CONTRACT ADDENDUM NO. 3

April 6, 2026

NOTICE TO ALL BIDDERS FOR THE: **Topeka & Shawnee County Public Library** Staff Spaces Renovations HTK Project No.: 2001.01-021

SHEET NUMBER:
A601

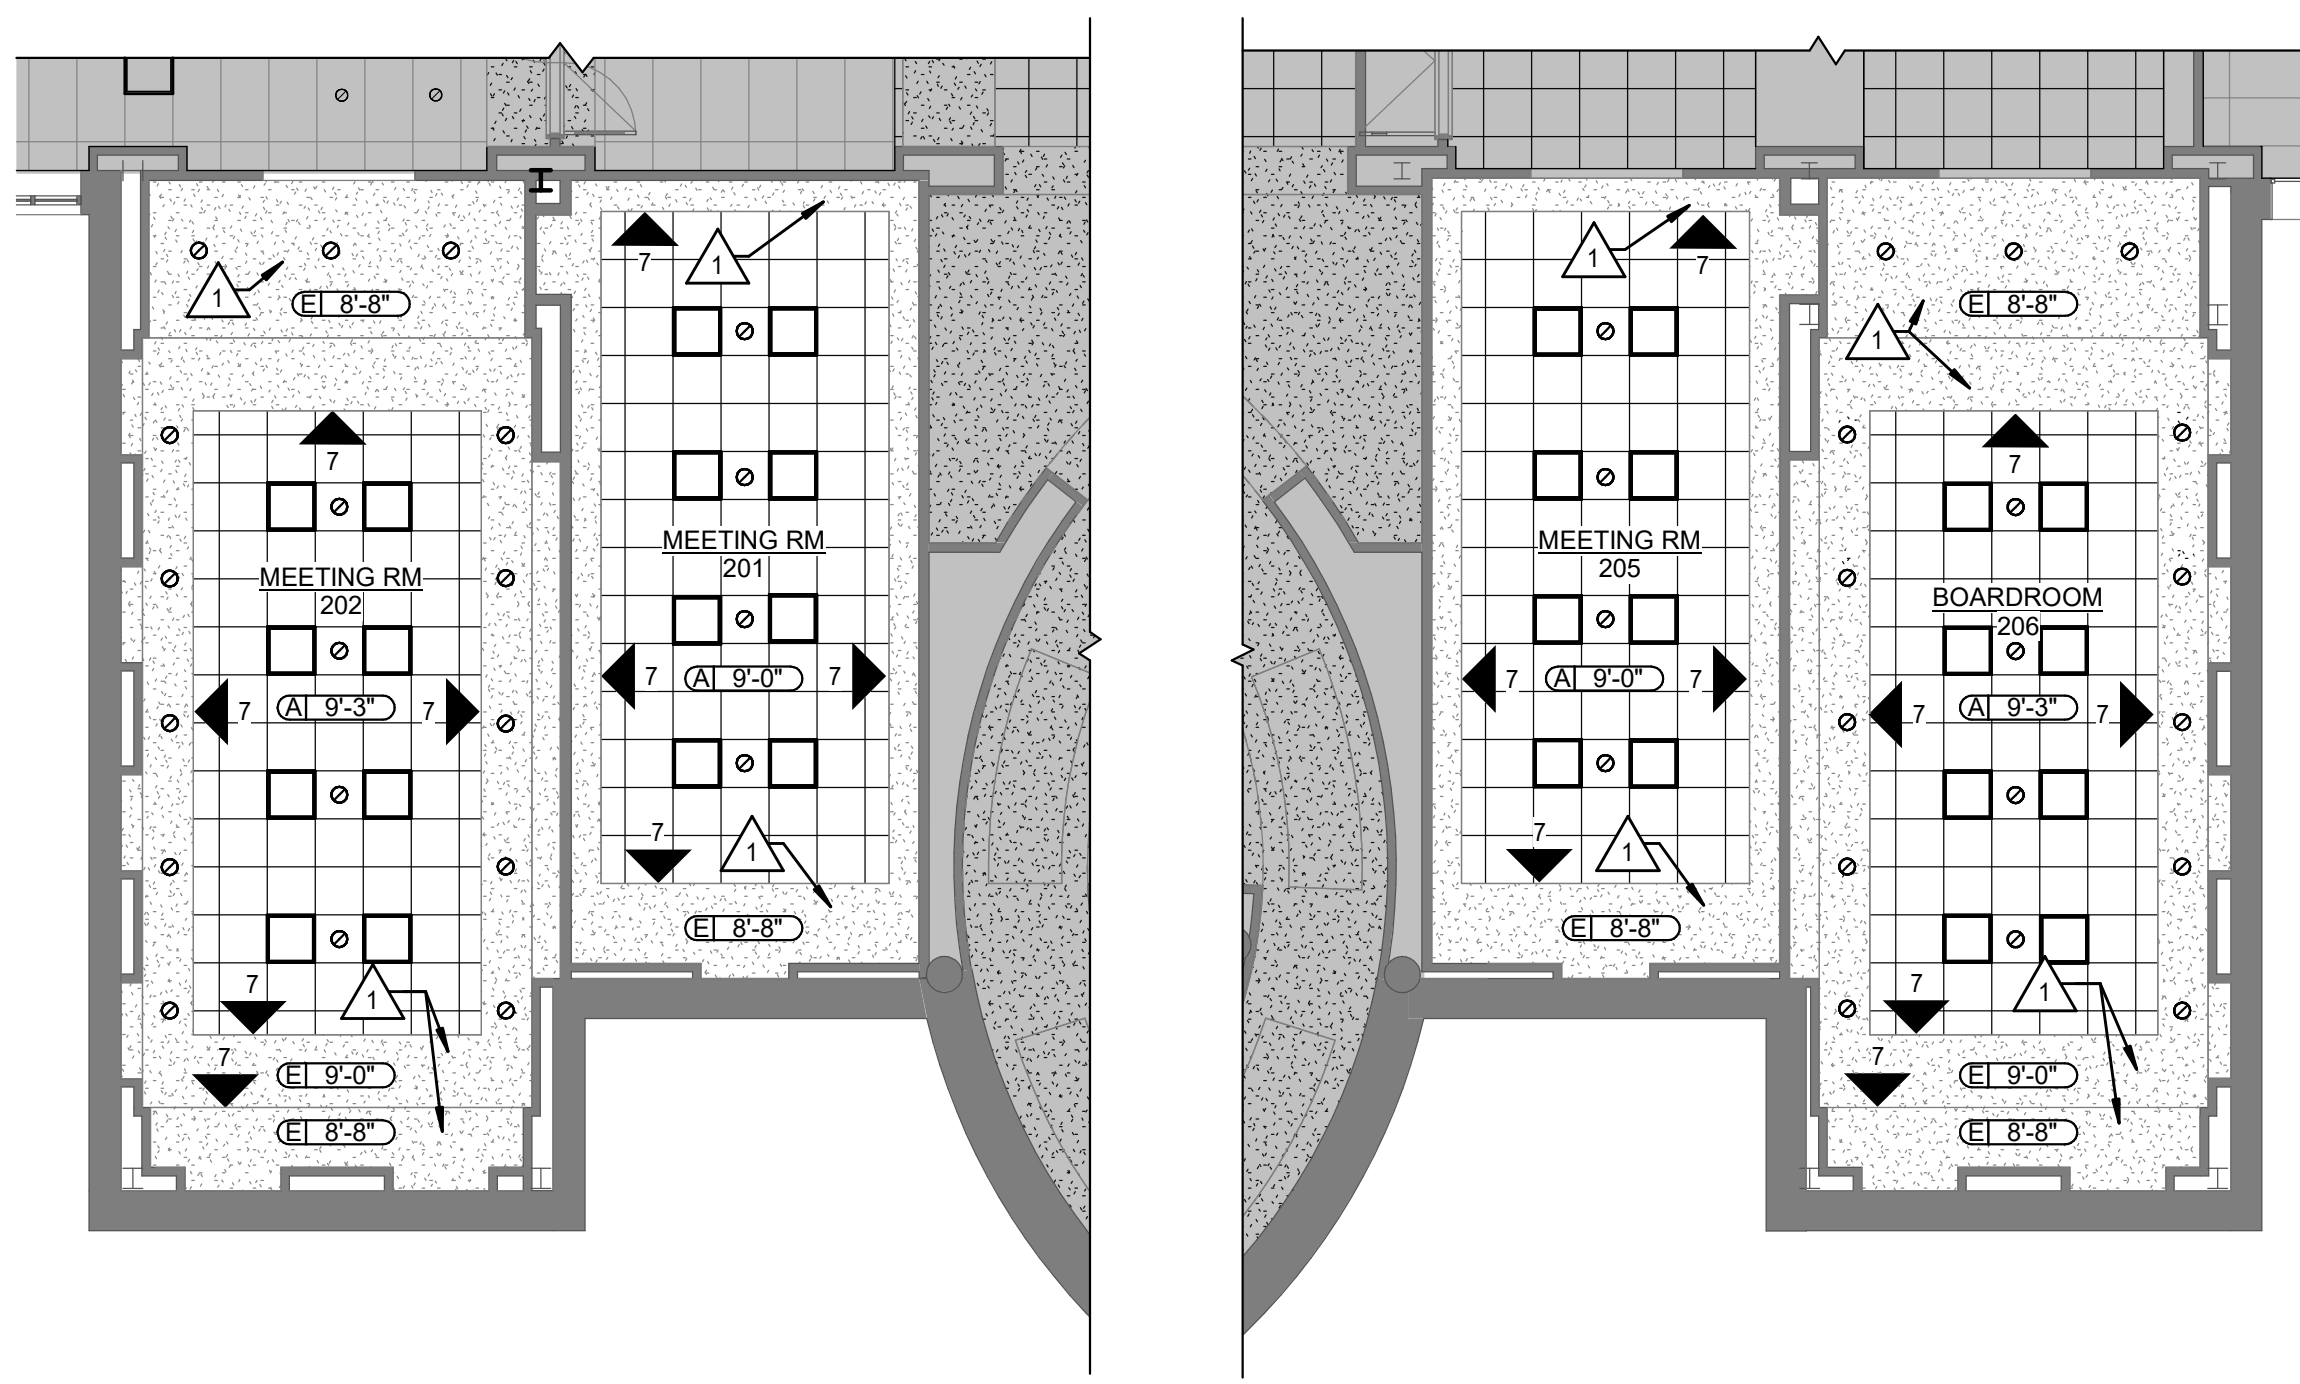
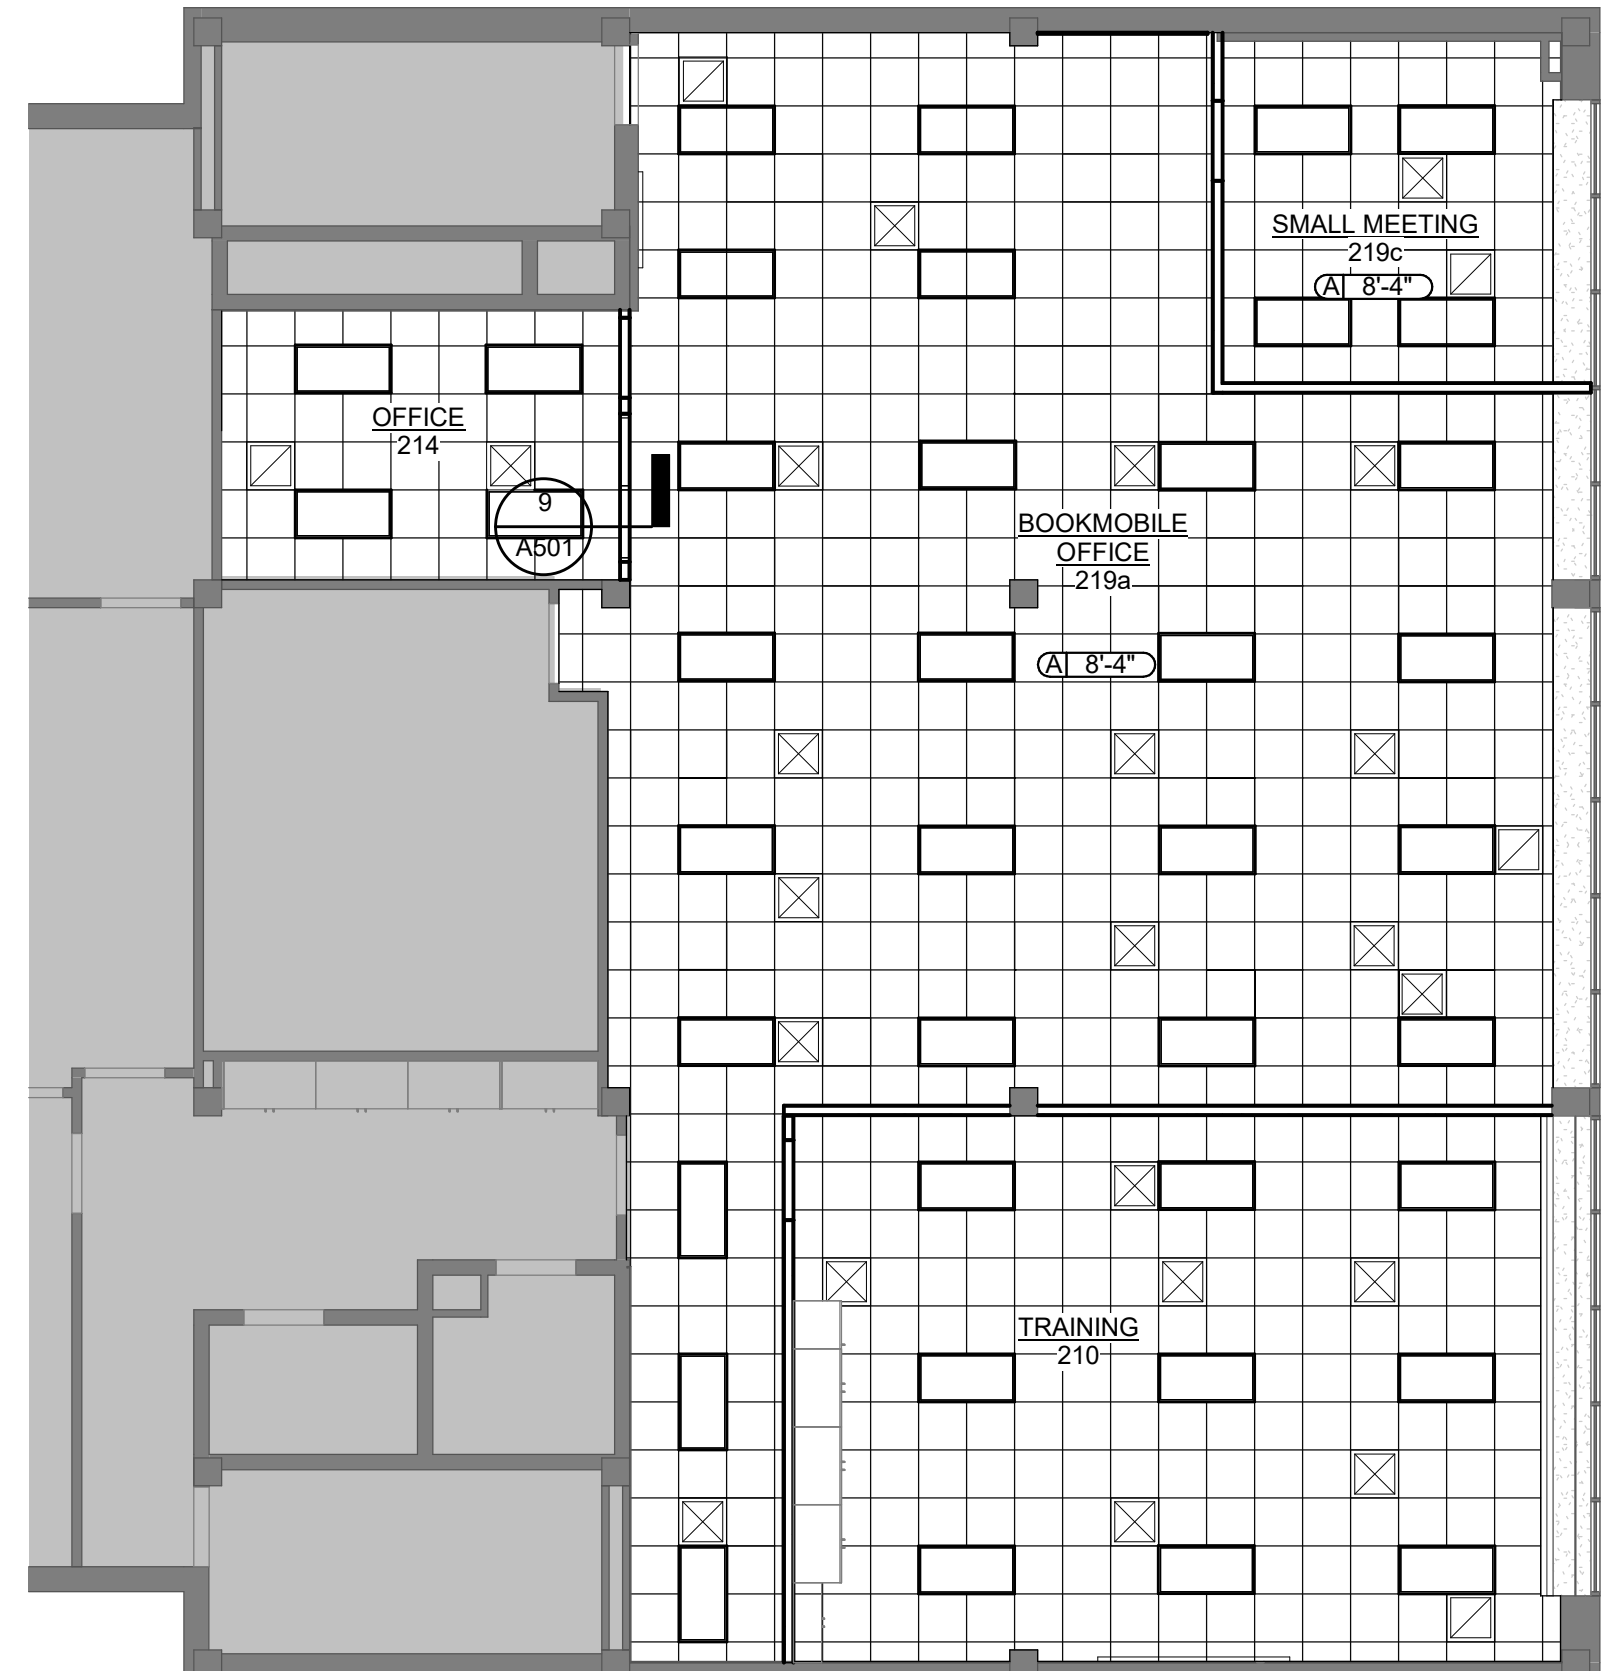
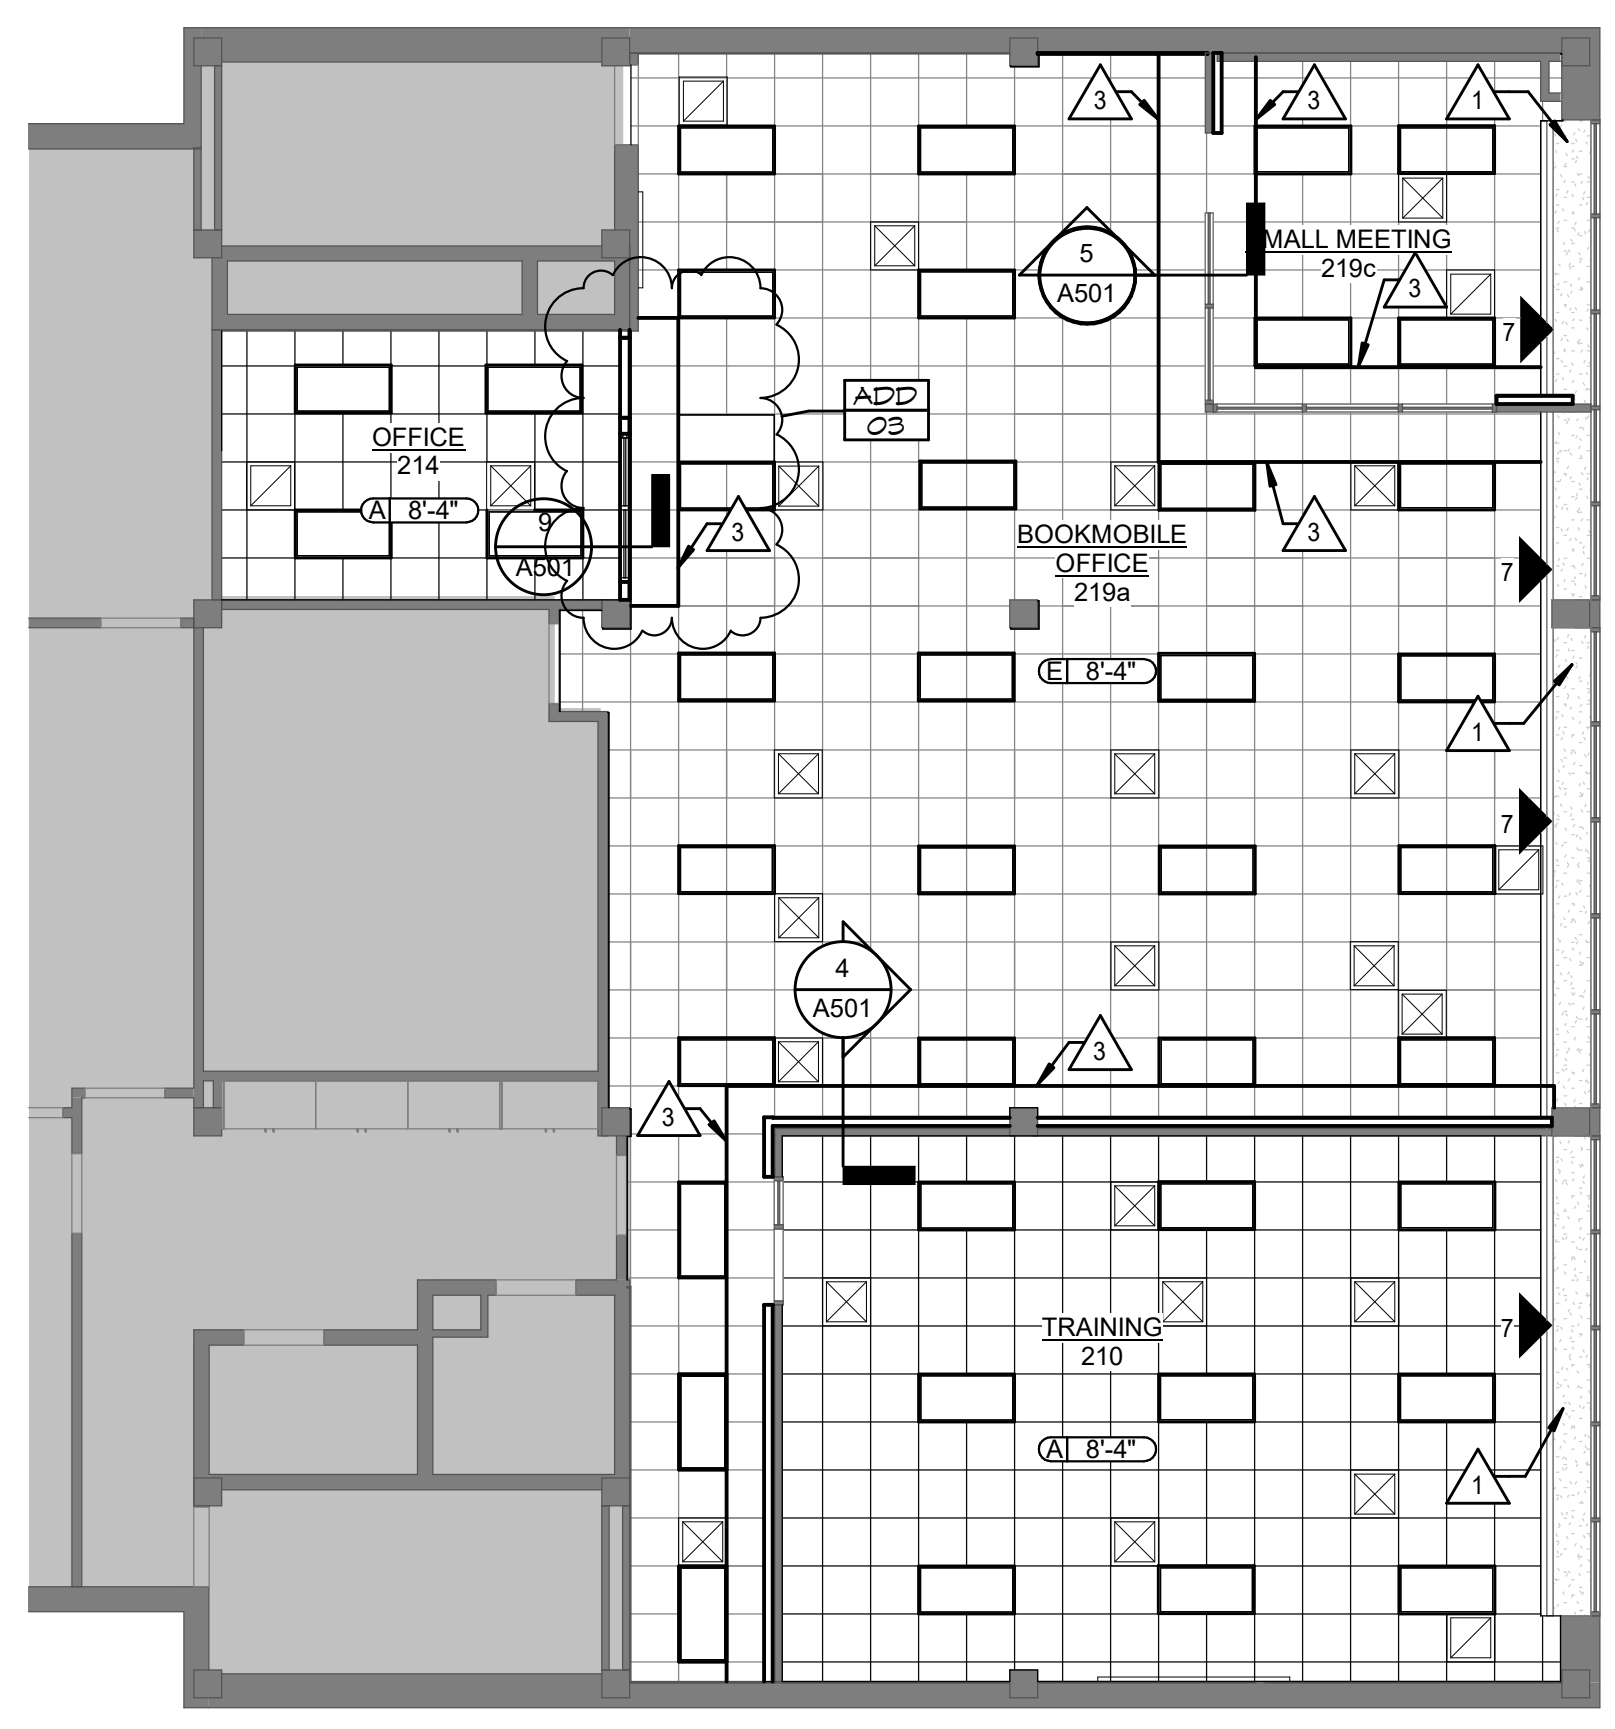
1. Add Plan Note 3 to existing ceiling tile and grid outside of Office 214.

3 DEMO PORTION OF EXISTING CLG TILE & GRID TO NEAREST FULL TILE. INSTALL NEW TILE & GRID AT DEMOED PORTION.
